Access Compliance Report

Public Rights-of-Way

Intersection ID: 12377	Main Street: S_TRYON_ST	Cross Street: W_4TH_ST	Location: W
ADA ID: 8438D2301DBF	Ramp Type: PerpDiag	Initial Pass/Fail: Fail	Overall Compliance: No
		Severity Score: 25

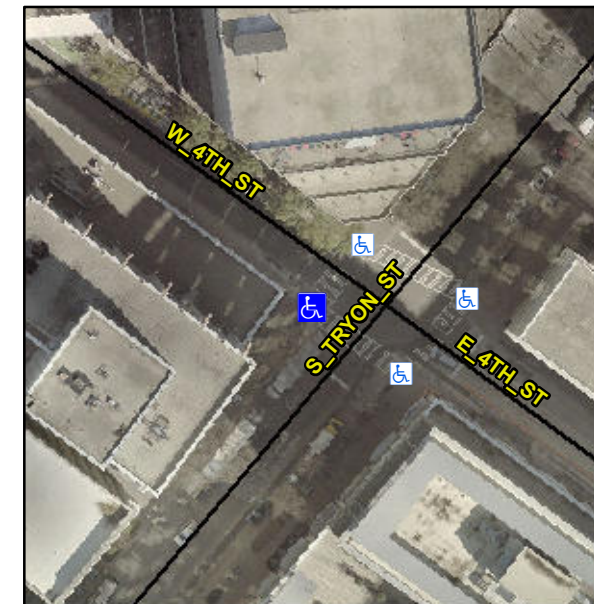
Compliance	Description	Data	Compliance	Description	Data
N/A	Ramp Length (in)	25.0	Yes	Ramp Slope (%)	6.5
Yes	Ramp Width (in)	57.0	No	Ramp XSlope (%)	7.1
N/A	Flare Type LT	N/A	N/A	Flare Type RT	N/A
N/A	Flare Slope LT (%)	N/A	N/A	Flare Slope RT (%)	N/A
N/A	Flare Traversable LT?	N/A	N/A	Flare Traversable RT?	N/A
N/A	Landing Length (in)	N/A	N/A	DWS Provided?	N/A
N/A	Landing Width (in)	N/A	N/A	DWS Contrast?	N/A
N/A	Landing Slope (%)	N/A	N/A	DWS Length (in)	N/A
N/A	Landing X Slope (%)	N/A	N/A	DWS Full Width?	N/A
N/A	Landing Curb? (Y/N)	N/A	N/A	DWS Offset (in)	N/A
N/A	Shared Landing?	N/A			
N/A	Gutter Ponding?	N/A	N/A	Gutter Slope (%)	N/A
N/A	Gutter Lip Ht (in)	N/A	N/A	Gutter X Slope (%)	N/A
N/A	Painted X Walk1?	Yes	N/A	Painted X Walk2?	Yes
	X Walk 1 Direction	To SE		X Walk 2 Direction	To NE
N/A	X Walk 1 Width (in)	108.0	N/A	X Walk 2 Width (in)	145.0
	X Walk 1 Slope (%)	0.8		X Walk 2 Slope (%)	0.4
	X Walk 1 X Slope (%)	0.8		X Walk 2 X Slope (%)	0.1

Remove & Replace Curb Ramp With Two New Directional Ramps or Equivalent.

R304.5.3
